# UNITED STATES PATENT AND TRADEMARK OFFICE

APPLICATION NO.	FILING DATE	FIRST NAMED INVENTOR	ATTORNEY DOCKET NO.	CONFIRMATION NO.
10/673,643	09/30/2003	Victor T. Massey	081589-0306133	1141
28410 7590 01/11/2008 BERENATO, WHITE & STAVISH, LLC 6550 ROCK SPRING DRIVE SUITE 240 BETHESDA, MD 20817			EXAMINER STRIMBU, GREGORY J	
			ART UNIT 3634	PAPER NUMBER
			MAIL DATE 01/11/2008	DELIVERY MODE PAPER

# Office Action Summary

**Fig. 24**

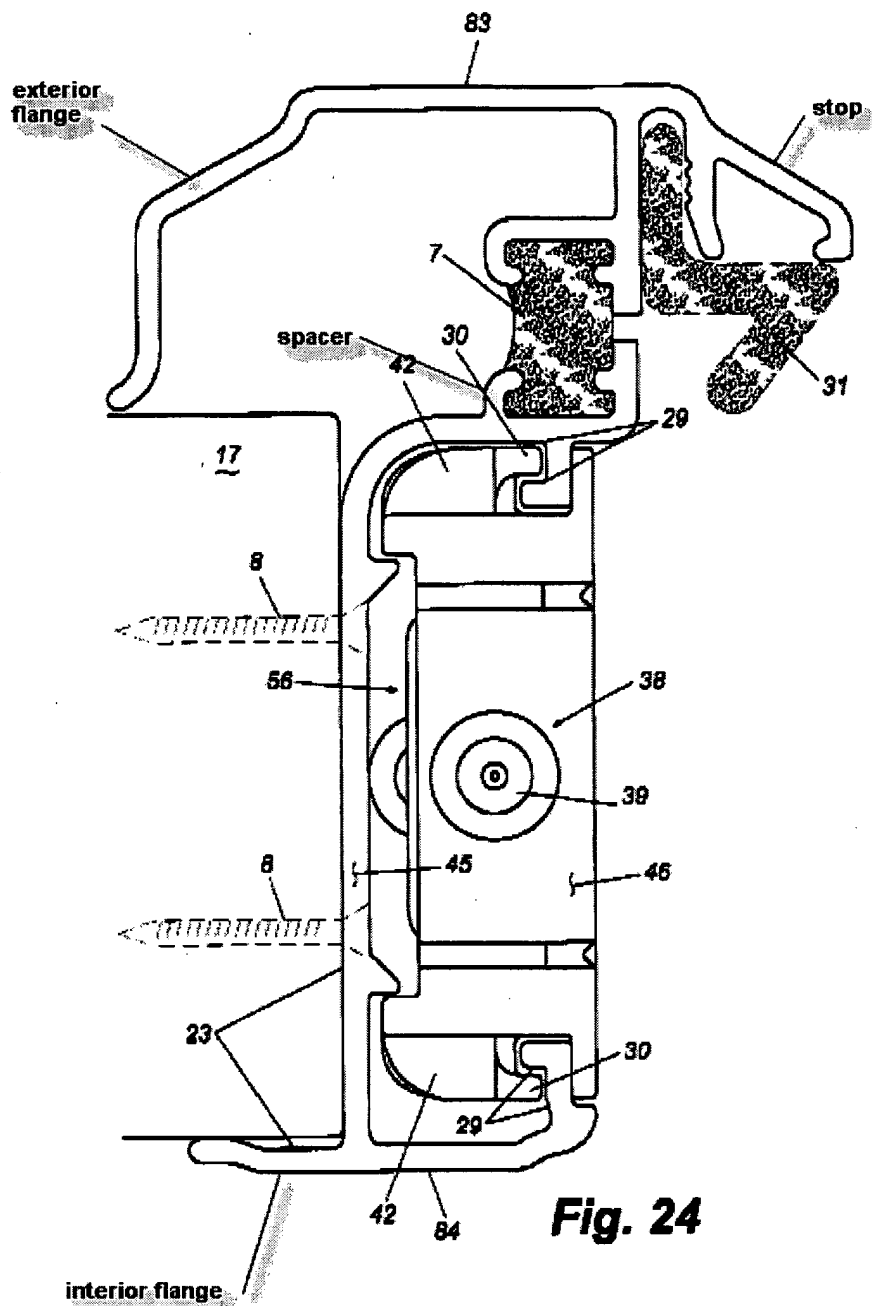
Claims 1-21 and 32-48 are rejected under 35 U.S.C. 103(a) as being unpatentable over Massey et al. (6491326) in view of Hendrickson et al. (US 6684571). Massey et al. discloses an astragal assembly 27 for attachment to a passive door 17 having an interior surface, an exterior surface opposite to the interior surface, and an outer edge extending from the exterior surface to the interior surface, comprising: a metallic rail 28 having an exterior portion 83, an interior portion 84 spaced from and opposed to the exterior portion, and a side portion 45 extending between the exterior portion and the interior portion disposed opposite the outer edge of the passive door when the astragal assembly is affixed thereto, a spacer (labeled below) extending outwardly from a major surface of the side portion and having a distal end to maintain an air gap between a surface of the outer edge of the passive door and the side portion of the metallic rail when the astragal assembly is affixed thereto to allow air flow between the outer edge of the passive door and the side portion of the metallic rail, an interior flange (labeled below) extending away from where said interior portion meets

said side portion to engage the interior surface of the passive door, and an exterior flange (labeled below) opposite said interior flange and extending away from where said exterior portion meets said side portion to engage the exterior surface of the passive door, wherein an elongated open channel is defined in the metallic rail with sides formed by the exterior portion and the interior portion and a base formed by the side portion, the elongated open channel having an opening extending between the exterior portion and the interior portion and opposed to the side portion; and an insert 25 retained within the elongated open channel in the metallic rail, a stop (labeled below), a gasket 31, a thermal break 7, hooks 29 Massey et al. is silent concerning a wooden insert.

It would have been obvious to one of ordinary skill in the art to provide the insert of Massey et al. with a wood construction, as taught by Hendrickson et al., to improve the aesthetics of the astragal assembly.

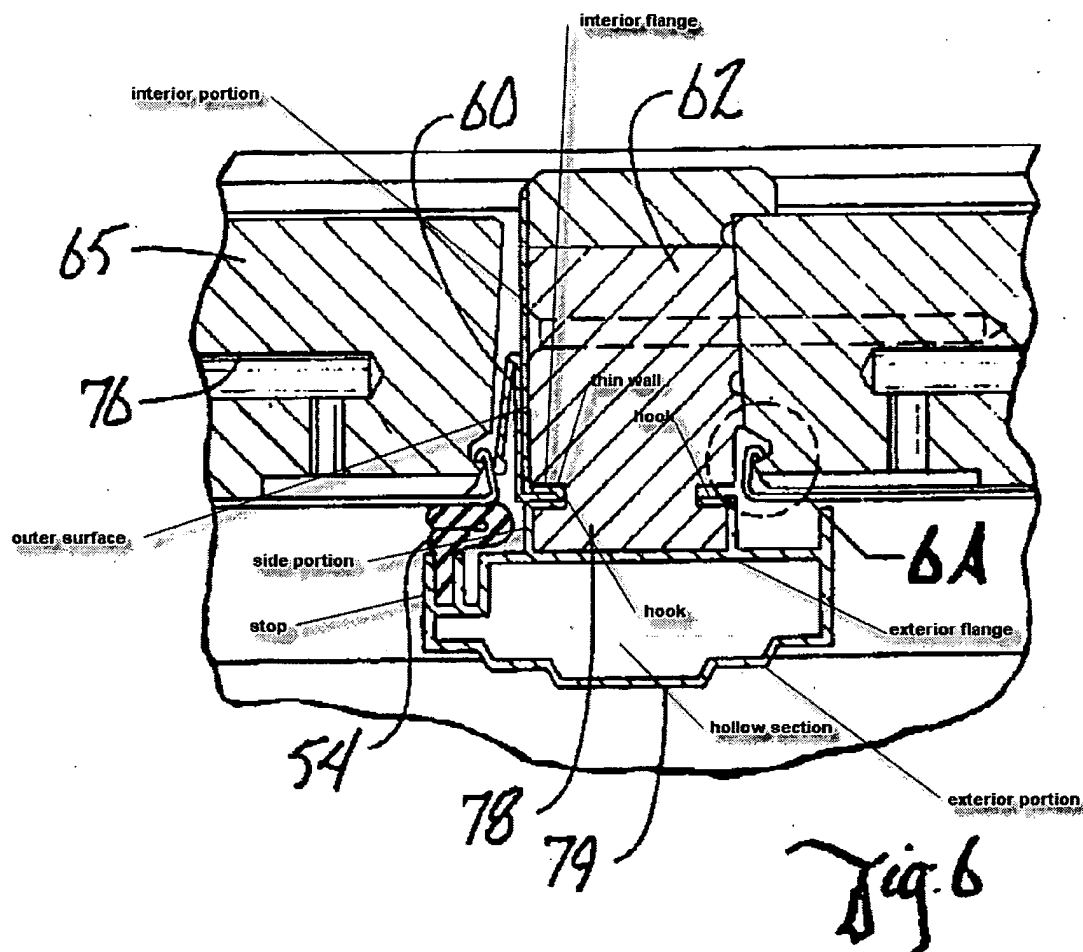
Claims 32-36 and 38 are rejected under 35 U.S.C. 102(b) as being anticipated by Hagemeyer et al. (US 4573287). Hagemeyer et al. discloses an astragal comprising: an extruded aluminum rail 79 with an exterior portion (labeled below), an exterior flange

(labeled below) extending from a first side of said exterior portion, and a stop (labeled below) extending from a second side of said exterior portion opposite to the first side, an interior portion (labeled below) spaced from and opposed to the exterior portion, an interior flange extending from the second side of the interior portion opposite from and substantially parallel to the exterior flange, and a side portion (labeled below) extending between where the exterior portion meets the exterior flange and where the interior portion meets the interior flange, the side portion having a fastening formation and a spacer 60 extending outwardly from a surface thereof; and a wooden insert member 78 retained substantially within a channel in the extruded aluminum rail formed by the exterior portion, the interior portion and the side portion, wherein the insert presents an outer surface (labeled below) for attachment to hardware, and the spacer extends away from the channel, a hollow section (labeled below) and hook (labeled below), the interior portion includes a thin wall (labeled below) and a hook (labeled below) extending into the channel, the side portion includes a thermal break comprising the air pocket formed between the side portion and the seal, a strike plate (not shown).

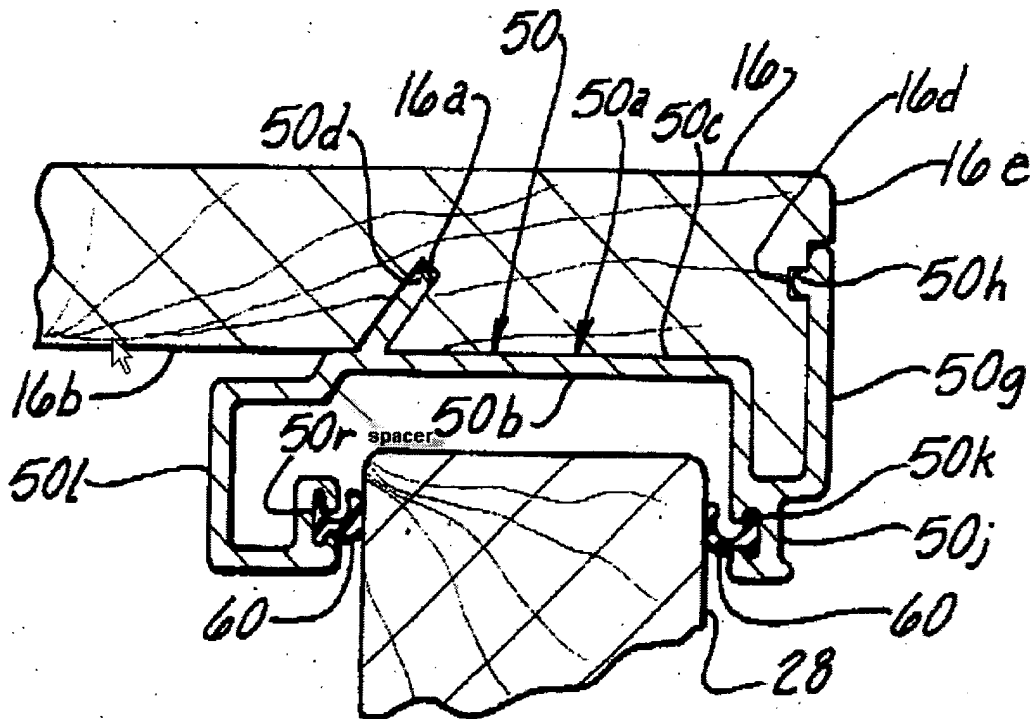
Claims 42-45 are rejected under 35 U.S.C. 102(b) as being anticipated by Clancy et al. Clancy et al. discloses an astragal assembly usable with an active door and a passive door having an exterior surface, an interior surface opposite to the exterior surface, and an outer end disposed between the exterior surface and the interior surface, the assembly comprising: a frame 48 including an interior portion 48d, an exterior portion 48g spaced apart from and opposed to the interior portion, a side portion 48b extending between the interior portion and the exterior portion opposite to

the outer end of the passive door when the astragal assembly is attached thereto, an interior flange 48l extending from where the interior portion meets the side portion to engage the interior surface of the passive door when the astragal assembly is attached thereto, an exterior flange 48j extending from where the exterior portion meets the side portion to engage the exterior surface of the passive door when the astragal assembly is attached thereto, and a channel formed by the exterior portion, the interior portion, and the side portion of the frame; an a door stop 48q extending from the exterior portion of the frame on the opposite side from where the exterior flange is located, and an insert member 12 disposed in the channel and having a surface exposed to the active door when the astragal assembly is attached to the passive door, a spacer (labeled below), the insert member is wooden and the frame is metallic based on the cross sectional shading as shown in figure 3.
